ADDENDUM NO. 002 (Rev 01/2017)

ISSUE DATE: **03/12/2024**

RE: **GRAINGER HALL 2ND & 5TH FLOOR RENOVATION
PHASE 2 - 5TH FLOOR OFFICE RENOVATION &
PHASE 3 - 2ND FLOOR NW CORNER RENOVATION
UNIVERSITY OF WISCONSIN-MADISON
610 WALNUT STREET
MADISON, WISCONSIN**

UWSA Project No. **A-22-021**
UW Madison Project No. **0140-2303**

1 2ND FLOOR DEMOLITION PLAN - ELECTRICAL
SCALE: 1/4" = 1'-0"
12' 0" 1' 0" 5' 0" 10' 0"

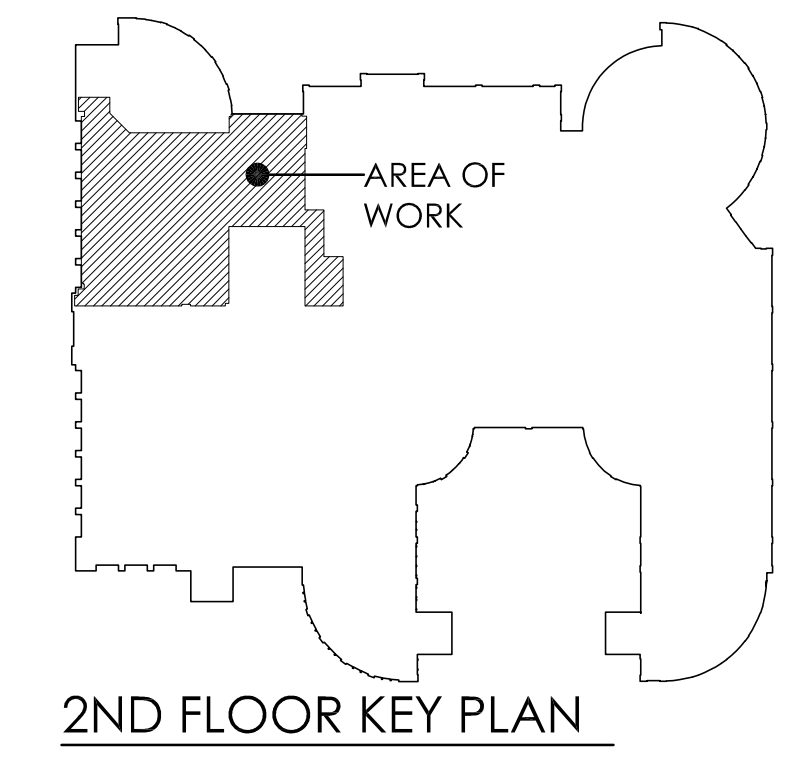
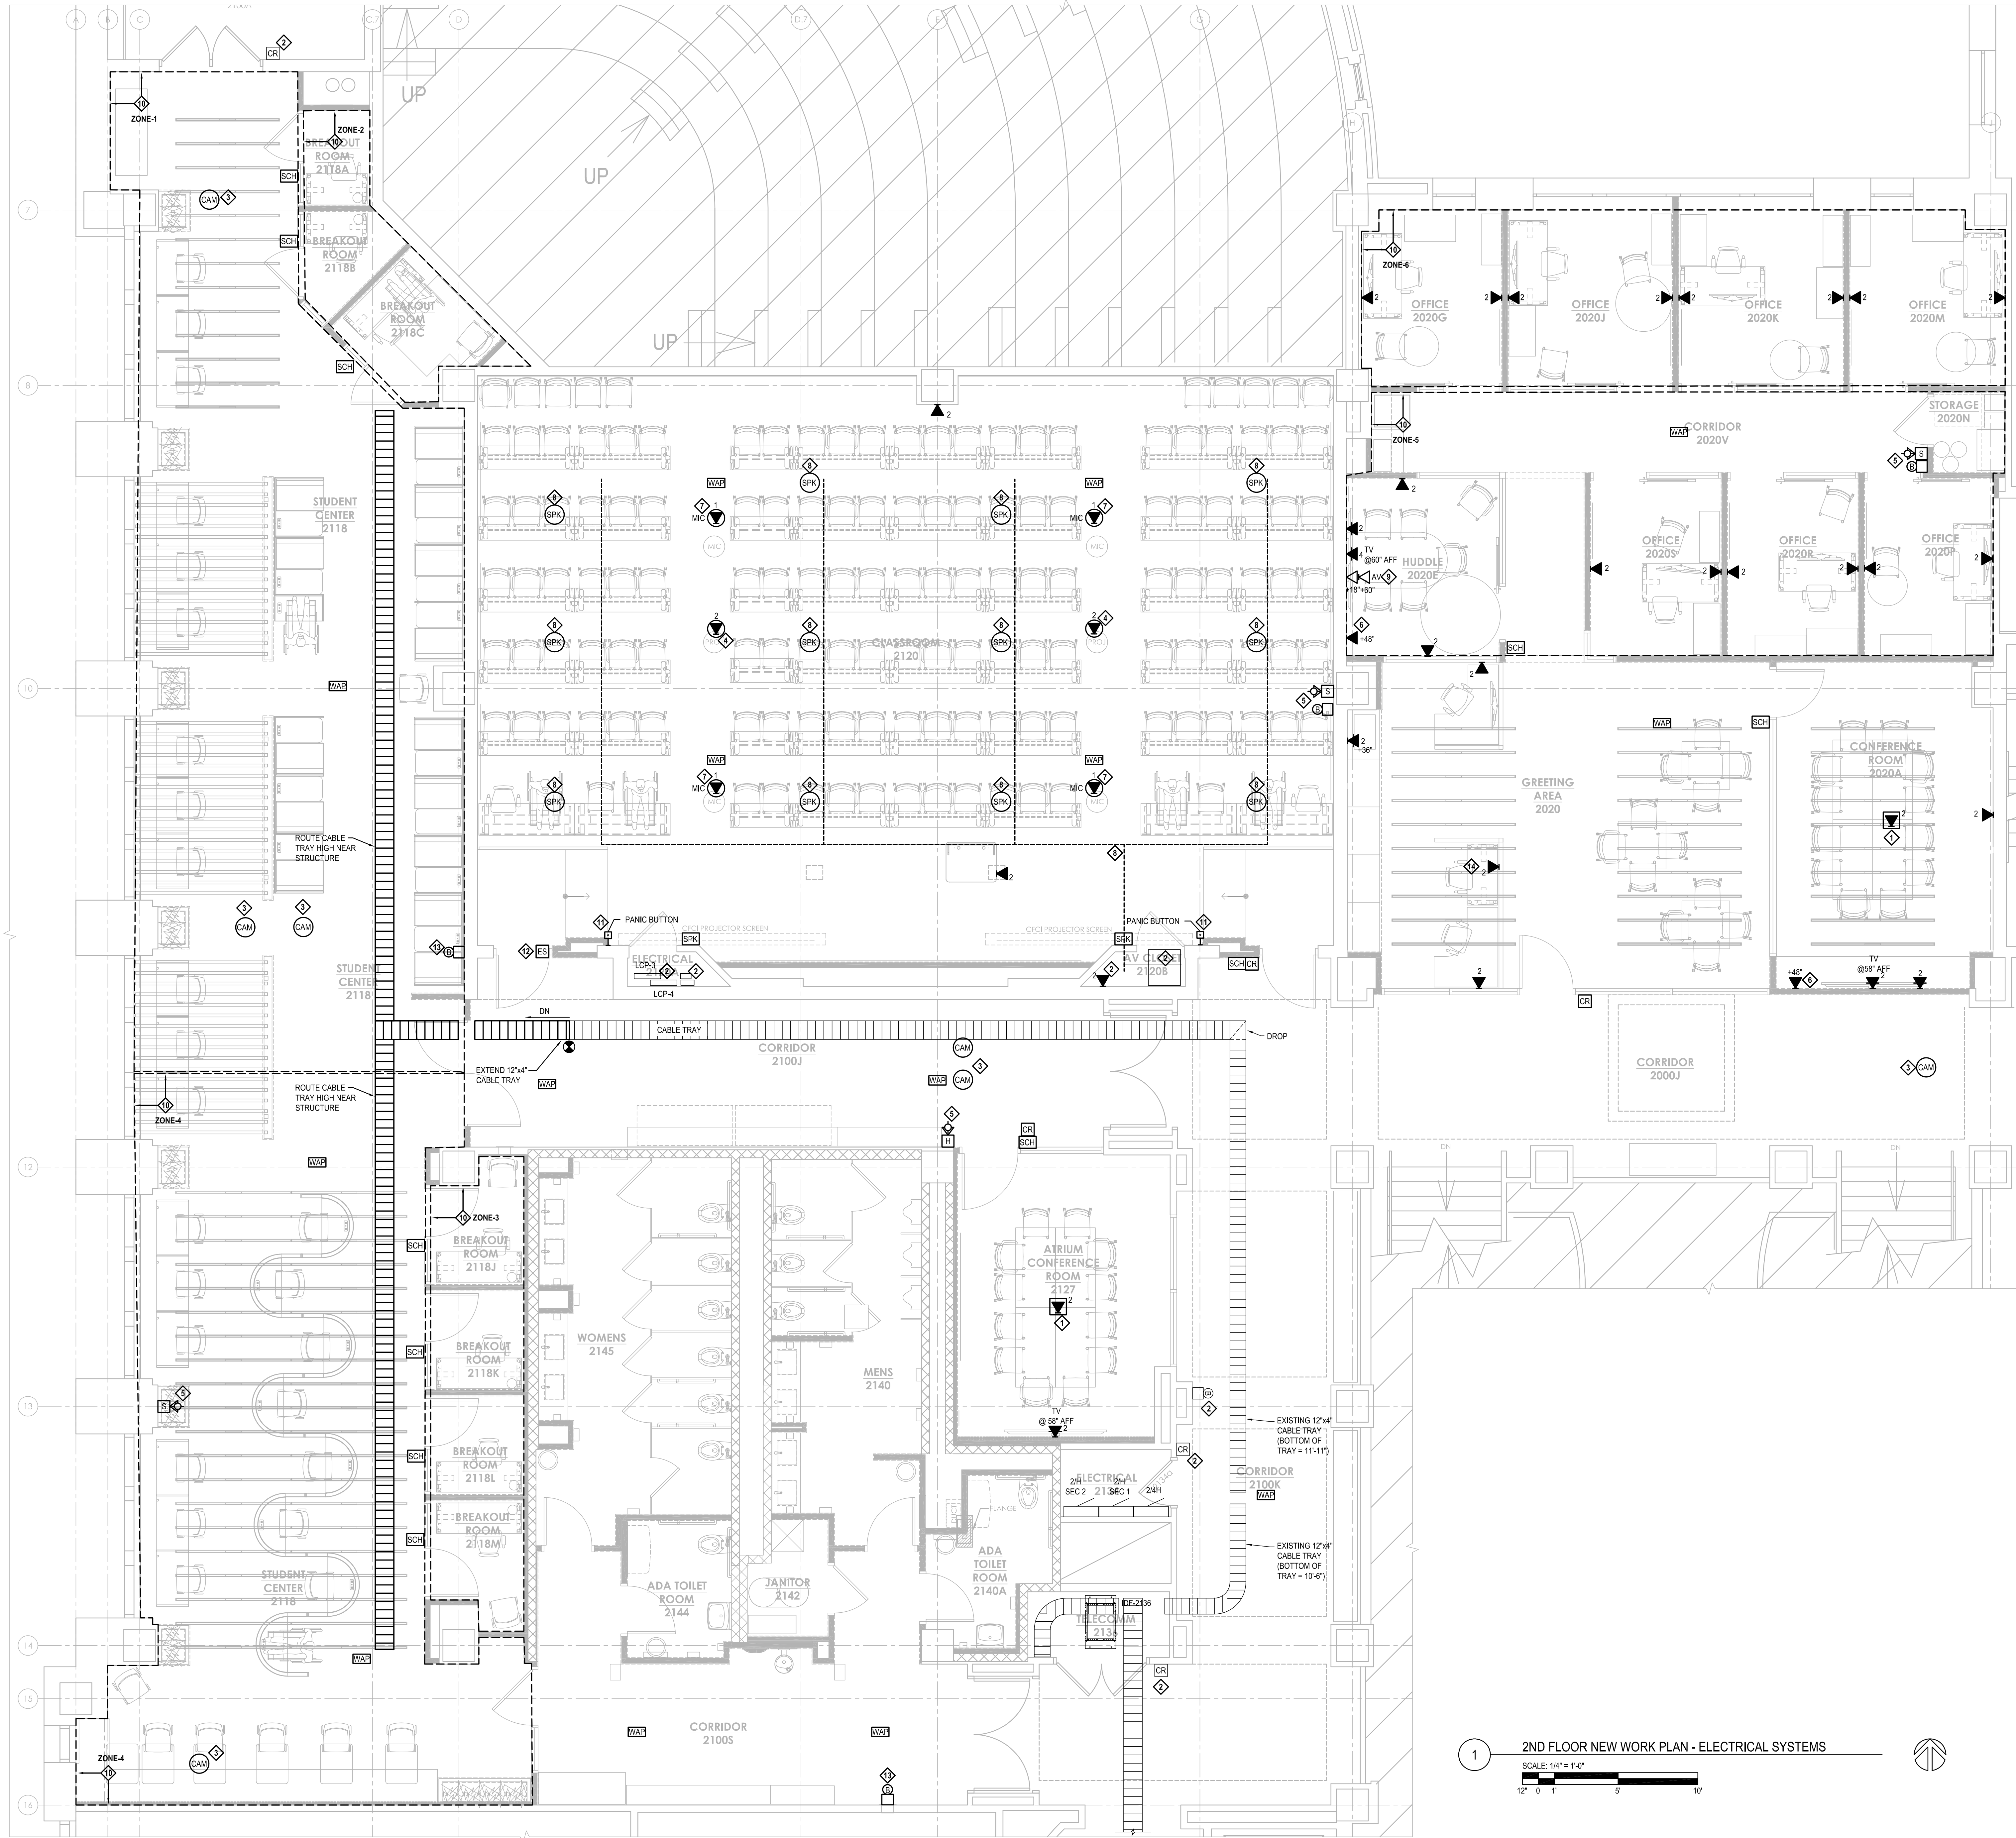
- i. **REVISE:** Demolition Note 5 to be revised. Remove last sentence "SEE NEW WORK FOR PRECISE LOCATIONS." See Sheet ED101.
- d. Sheet ES101
 - i. **REVISE:** General Note 2. Correct spelling of "APPLIFIERS" to AMPLIFIERS. Then add the following after the period: PROVIDE SHOP DRAWINGS INDICATING CODE-COMPLIANT PLACEMENT OF NEW SPEAKERS, STROBES, PULL STATIONS AND OTHER REQUIRED DEVICES. See Sheet ES101.
